To: Layla Rosales
From: Hannah Hippely
Date: October 14, 2019
Re: PP-000935-2017: Erie Highlands Preliminary Plat No. 4
cc: Deborah Bachelder

To: Hannah Hippely
From: David Pasic, P.E., Civil Engineer
Date: July 18, 2019
Subject: **Erie Highlands Planning Area 9 Preliminary Plat**
CC: Joe Smith, Wendi Palmer, Chad Schroeder, Tyler Burhenn

**RE: ERIE HIGHLANDS PLANNING AREA 9, PRELIMINARY PLAT NO. 4 (FILINGS 16 & 17)
DRAINAGE REVIEW**

DETACHED WALK

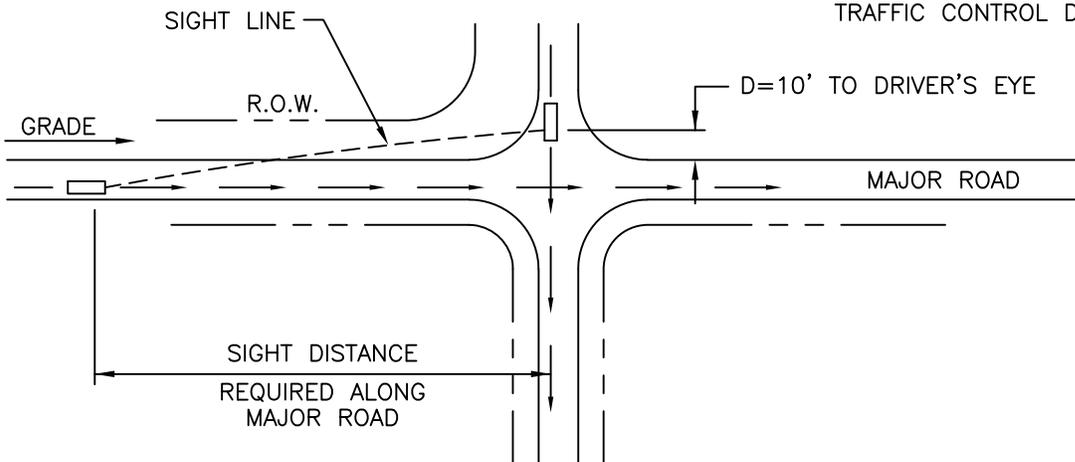
- No trees are to be located within 55' from the point of curb return at road intersections where a stop sign is present. This issue is currently affecting several intersections where stop signs are present. See attached Detail ST5 for additional clarification.
- Update native seed table to reflect the current "Short Grass Prairie Seed Mix" that can be found on Page 1000-25 at the following link:
<https://www.erieco.gov/DocumentCenter/View/10043/Section-1000---2019-Parks-Construction?bidId=>

NO TREES IN TREE LAWN WITHIN 55 FEET OF SIGN. ANY OTHER PLANTS AND LANDSCAPING MUST BE APPROVED BY THE PARKS AND RECREATION DIRECTOR OR DESIGNEE.
